UNITED STATES
DEPARTMENT OF THE INTERIOR
BUREAU OF LAND MANAGEMENT

FORM APPROVED
OMB NO. 1004-0137
Expires: January 31, 2018**SUNDRY NOTICES AND REPORTS ON WELLS**
*Do not use this form for proposals to drill or to re-enter an abandoned well. Use form 3160-3 (APD) for such proposals.***SUBMIT IN TRIPLICATE - Other instructions on page 2**

8. Well Name and No.
BUCK 20 FEDERAL 5H

WELLBORE SKETCH
ConocoPhillips Company -- Permian Basin Business Unit

WELLBORE SKETCH
ConocoPhillips Company -- Permian Basin Business Unit

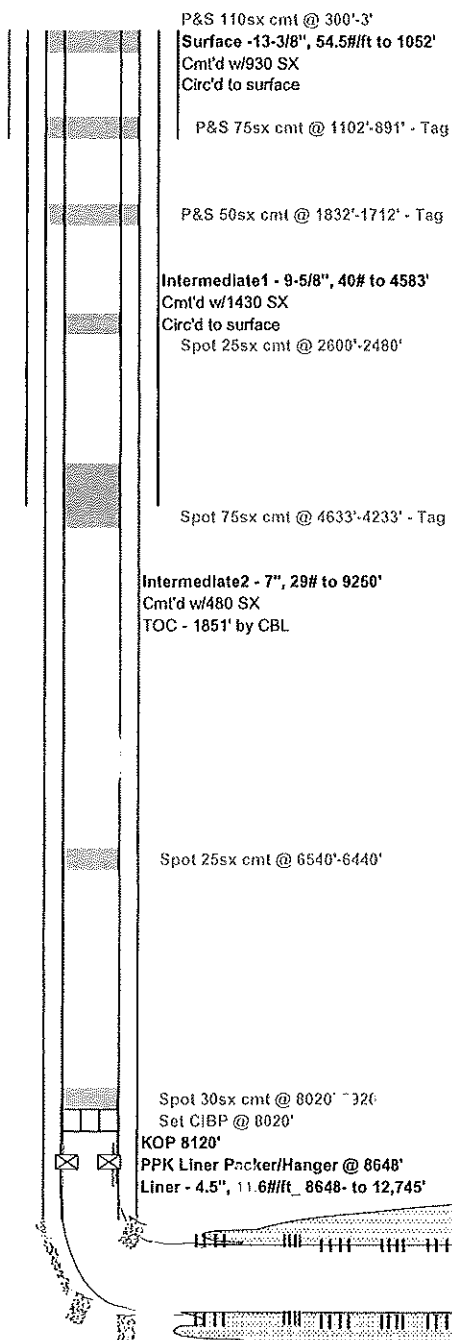
** BLM REVISED ** BLM REVISED ** BLM REVISED ** BLM REVISED ** BLM REVISED **

Intermediate1 - 9-5/8", 40# to 4583' *4585*

- 1) MIRU, POOH w/ Prod Equipment
- 2) Set CIBP @ 8020' Circ hole w/ MLF. Pressure test casing. 8600
- 3) Spot 30sx cmt @ 8020' - 7920' 8600 - 8091 (Top Liner & Bone Spring)
- 4) Spot 25sx cmt @ 6540' - 6440' 6380 (spacer)
- 5) Spot 75sx cmt @ 4633' - 4233' WOC-Tag (shoe and below) 4083 (B/salt)
- 6) Spot 25sx cmt @ 2600' - 2480'
- 7) Perf/Sqz 50sx cmt @ 1832' - 1712' WOC-Tag
- 8) Perf/Sqz 75sx cmt @ 1102' - 891' WOC-Tag (shoe, T/salt)
- 9) Perf/Circ 110sx cmt @ 300' - 3'
- 10) Verify cmt @ surface. RDMO. Cut off WH & anchors. Install P&A marker
